Safety Evaluation Report for the Model ES-3100 Package with Plutonium Oxide Content

Docket No. 10-57-9867

SUMMARY

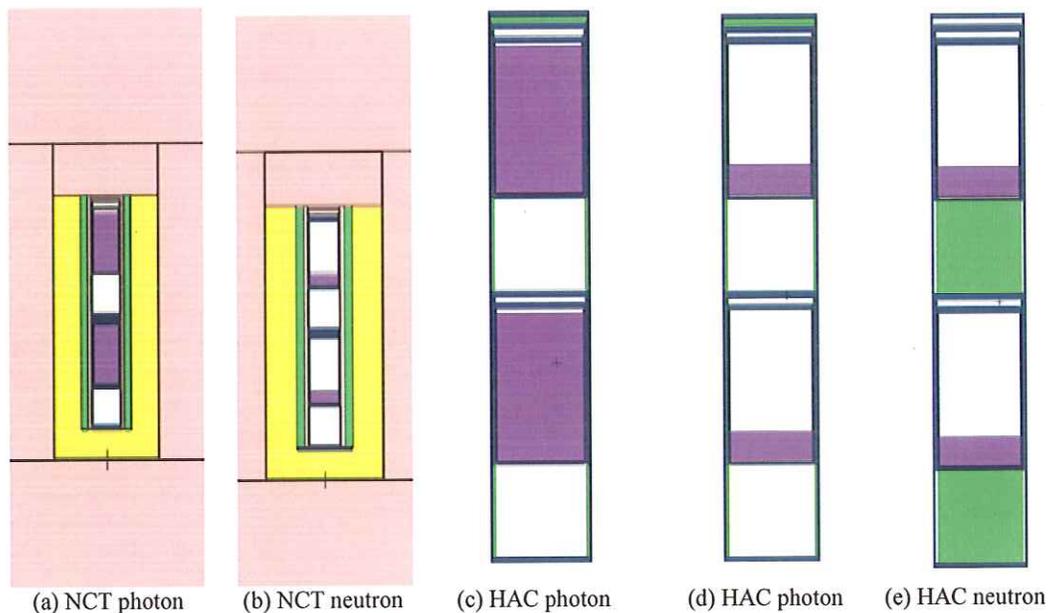
The bounding cases for the shielding calculations are determined by comparing radiation dose rates calculated from various models with different plutonium oxide content shapes and locations within the CV, as illustrated in Figure 5.1.

Photon dose rates are calculated at three densities: 11.46 g/cm^3 (the theoretical density of plutonium oxide), 7.0 g/cm^3 (the bulk density of plutonium oxide), and 2.308 g/cm^3 (calculated by dividing the mass by the volume of the 3013 container). In all SARP evaluations, the radius of the plutonium oxide cylinder is assumed to be 5.7 cm, and the height is adjusted for the density in each calculation to preserve the 5-kg plutonium oxide mass. However, for HAC side and top evaluations, the staff found that a shell model produces slightly higher dose rate for the side, and a much higher dose rates for the top when the two plutonium oxide contents are moved to the top of the 3013 inner containers (instead resting on the bottom, as in the SARP). Both aluminum spacers are modeled either as solid cylinders or as voids, with 6.0325-cm radii and 13.335-cm heights. The side photon dose rate is highest with the spacers modeled as voids and with 2.308-g/cm^3 density for plutonium oxide content; the bottom and top photon dose rates are highest with 11.46-g/cm^3 density for plutonium oxide content.
